## PLANNING DEPARTMENT STAFF REPORT AND FINDINGS

### ROLLING MEADOWS MINOR PARTITION – PRELIMINARY PARTITION APPROVAL (File MP 23–12)

#### Preliminary Partition Plan Map

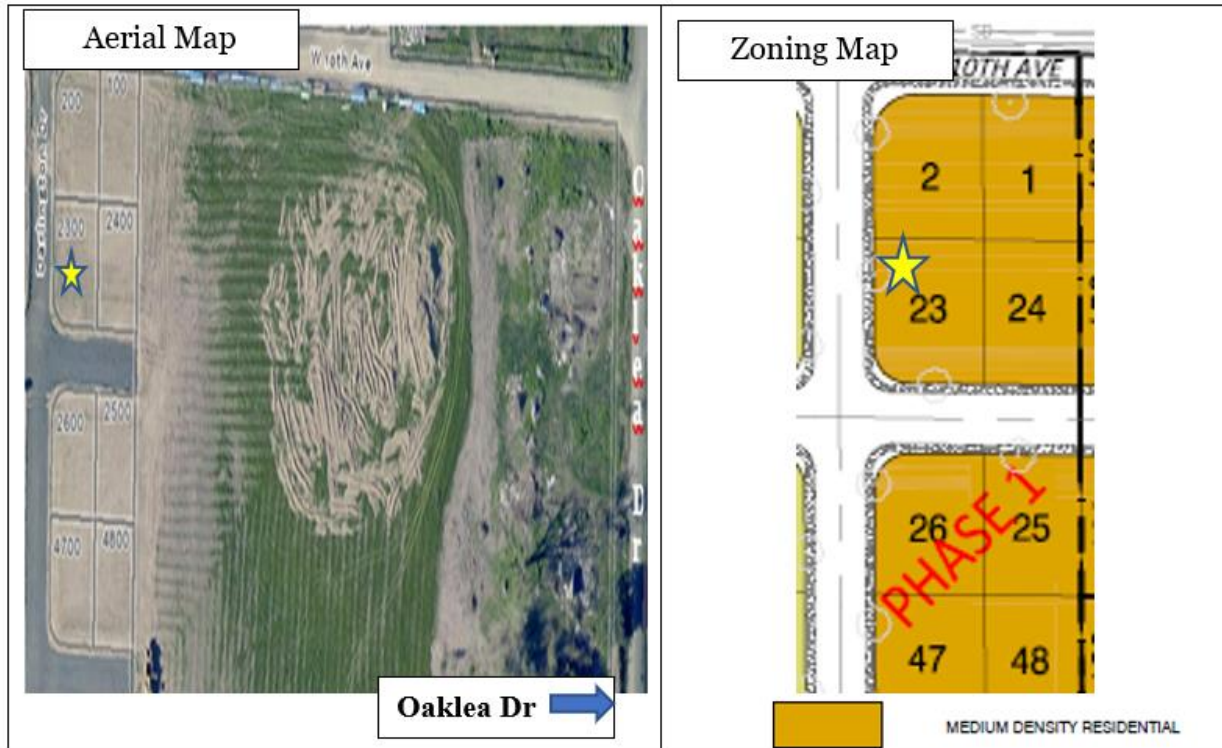
**Finding 9:** The preliminary plan has the date, north point and scale of the drawing. The dimensions of the property are adequately identified as adjacent tax lots are identified and numbered. The legal description of the property is Lot 23, Rolling Meadows PUD Phase 1. Neither the preliminary partition plan nor the supplemental materials identify the assessor's account number (Act #1914516).

**Finding 10:** The name and address of the owner/partitioner is present on the preliminary plan and its telephone number. However, the telephone number is included on the application form. The applicant's representative's name and address is listed on the preliminary plan as is Marcus Cross, the applicant's surveyor.

**Finding 11:** The preliminary plan shows 10<sup>th</sup> Avenue and Darlington Avenue and their right-of-way widths of 50 feet.

**Finding 12:** The preliminary plan depicts the layout of the proposed parcels and their number. The complete dimension of each parcel is included and their square footage.

**Finding 14:** The preliminary plan shows the location of two water easements. These easements were dedicated to the City as part of the approval of Phase 1 of the Rolling Meadows Subdivision.

**Finding 33:** The preliminary plan shows a 10' wide public utility easement that is dedicated to the city.

**Condition of Approval #1:** The final plat must show all easements. All easements must be recorded and the public utility easements dedicated to the City prior to final plat approval.
